1 July 2026

Subject: SSD-76210271 Bluestone Hardrock Quarry Project - Objection

APPENDIX A: GENERAL ASSESSMENT AND TECHNICAL DEFICIENCIES

Figure 2: Unmitigated proposed haulage road interface risks at Radford Park (Source: Google Streetview)

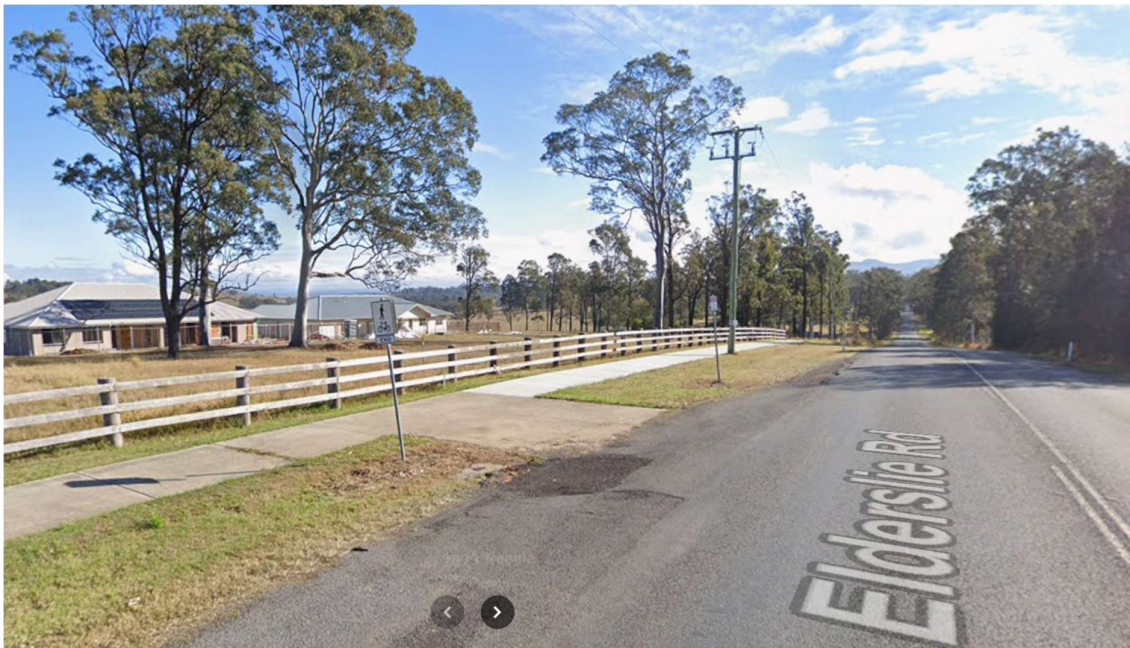
Radford Park's expanded footprint also has a 2.1km direct frontage to Elderslie Road, with 25 residential existing lots already backing directly onto the quarry's proposed haulage route and capacity for further lots to be created through additional delivery stages. As illustrated in **Figure 2**, these lots are deliberately designed with minimal, low-profile post-and-rail timber fencing and soft, grassy landscaping to protect the open, rural character of the estate. There are no structural acoustic barriers to shield these properties, which leaves them completely exposed to the unquantified and unmitigated impacts of the proposed quarry's haulage corridor.

The continuous imposition of heavy truck noise, exhaust emissions, and low-frequency vibrations strips away the acoustic and environmental amenity central to the estate's identity and only formal active recreational area. This represents a profound and sustained degradation of the local living environment – both real and perceived – that will directly suppress market demand and erode the long-term property values established by substantial private investment. The quarry project's documentation, specifically including its noise impact study, currently omits any modelling or mitigation measures for this part of the haulage corridor. The potential for significant environmental and amenity impacts here warrant further investigation prior to determination.

Figure 4: The proposed haulage route severs Branxton Town Centre’s functional service catchment

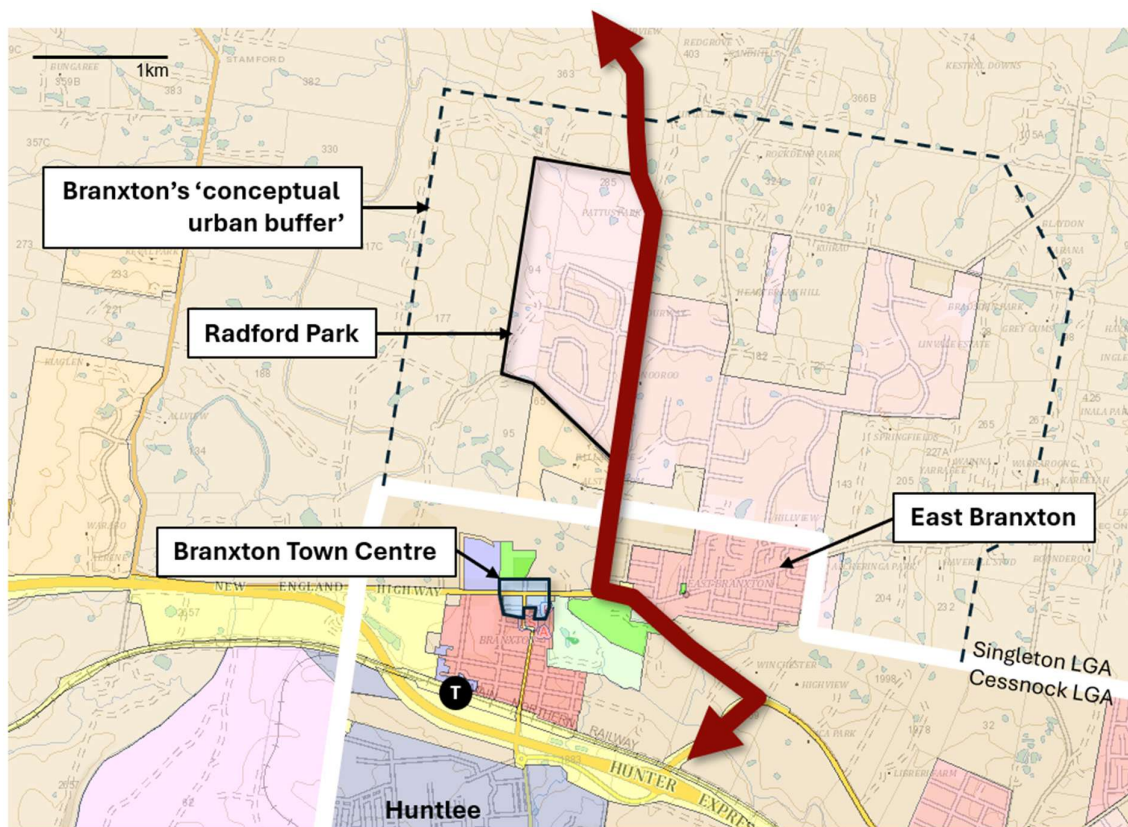
Branxton Town Centre’s local service area catchment (shown in **Figure 4**) largely draws from the wider Branxton village, East Branxton, and North Branxton, including Radford Park, along with visitors to the nearby Hunter Valley vineyards district.

However, this fragile, generation-long revitalisation process is directly threatened by the quarry proposal's haulage route. As demonstrated in **Figure 4**, the quarry project's proposed haulage route cuts directly through the centre of the Town Centre's catchment, inserting an intensive, high-frequency heavy industrial barrier that physically bisects Branxton Town Centre from its primary northern residential service catchments.

Figure 5: Westerly Supply Haulage Route Alignments (Source: National Heavy Vehicle Route Planner, <https://www.service.nhvr.gov.au/#page=informationHub/routePlannerTool>)

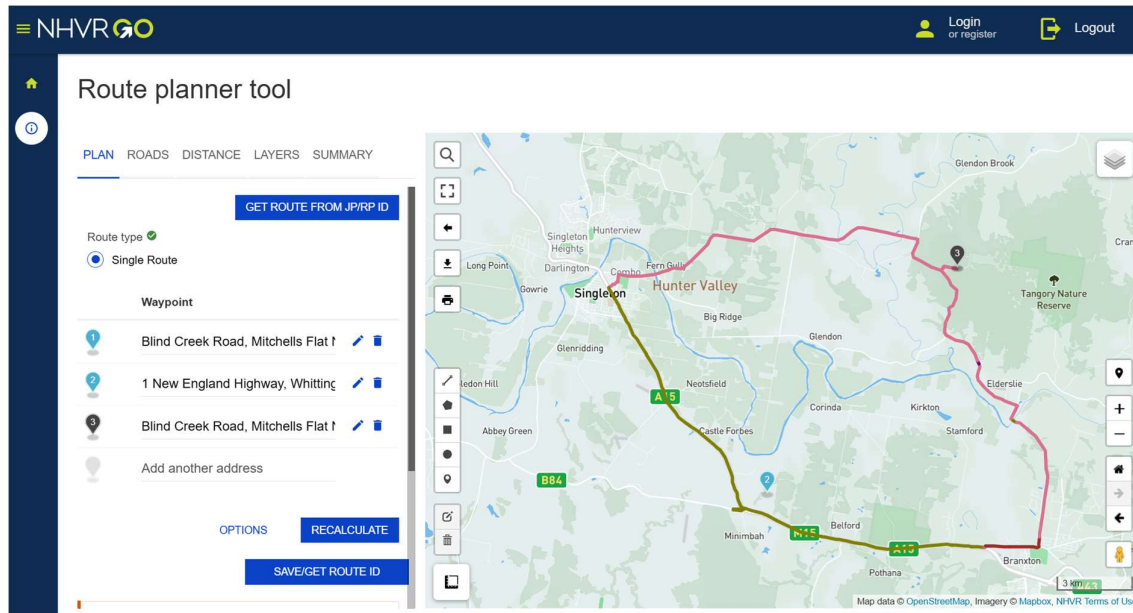
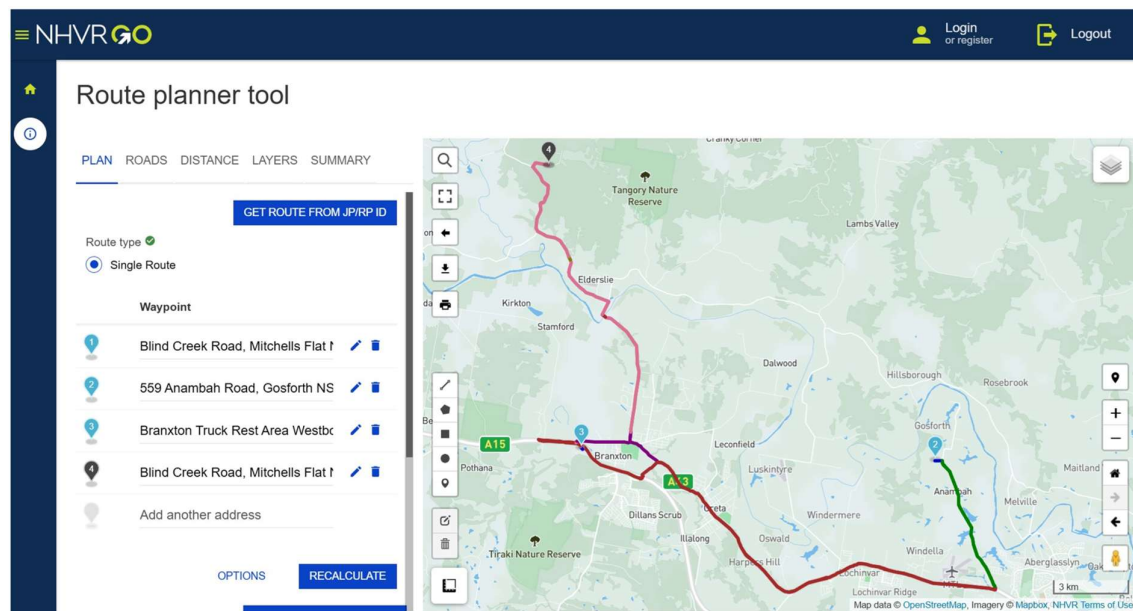
- **Western Access.** It is highly plausible that quarry material will be required for major industrial projects located in the Singleton and Muswellbrook areas, or that trucks will arrive to the site from the West.
- **Branxton Truck Rest Area.** Irrespective of the destination, drivers are highly likely to access truck rest facilities, located less than 2km to the west of the Elderslie Road – Maitland Street intersection.

Figure 5 and **Figure 6** illustrate that either of these operational realities would force heavy vehicle traffic directly through Branxton Town Centre's main street. This creates an immediate and direct conflict with the millions of dollars of public and private investment efforts injected over recent years to create a pedestrian and outdoor dining environment.

Figure 7: Proposed alternative approach to providing direct safe and attractive links to Branxton's Town Centre

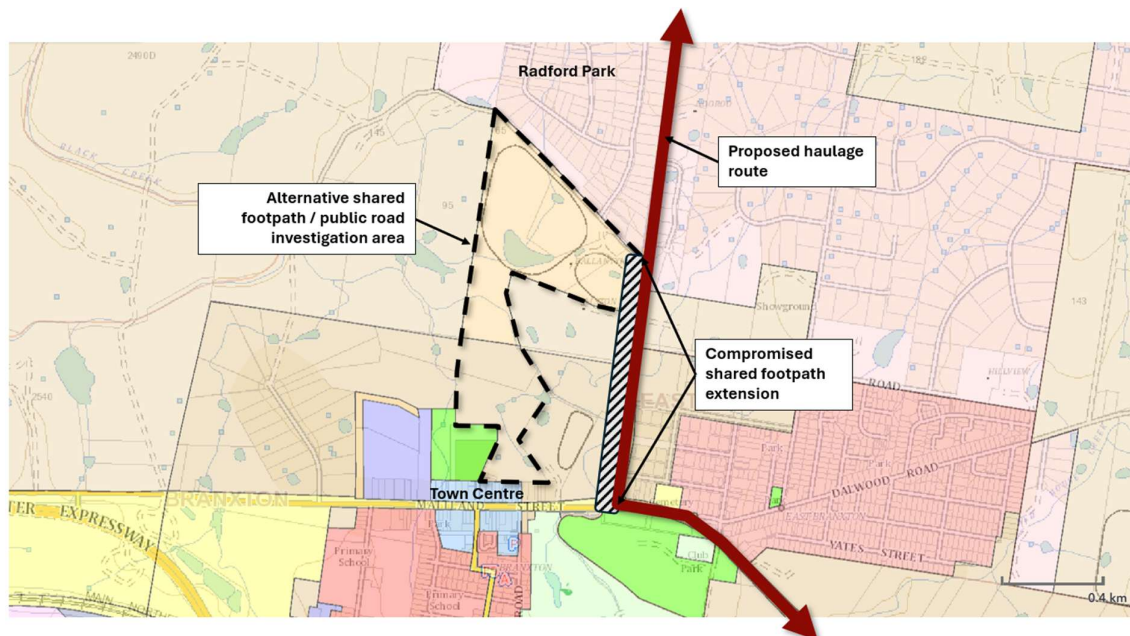
As illustrated by the dashed investigation area in **Figure 7**, the investigation area to provide a completely separated transport alignment involves only three properties.

Should the quarry project be supported to proceed, the severe road safety and amenity impacts along the Elderslie Road haulage corridor establish a direct infrastructure nexus. This nexus warrants a binding mitigation measure to provide financial contributions, which could be

directed towards formalising the planning, design and delivery of this link – in lieu of the highly compromised public link previously proposed along the exposed Elderslie Road verge – in partnership with both Singleton and Cessnock Councils. Crucially, this alternative alignment could also potentially be dedicated and upgraded to public road status, providing a vital local link to services including the Town Centre, train station and Vineyards District that completely bypasses the haulage road corridor and eliminates the need for hazardous right-turn movements out of the Radford Park estate.
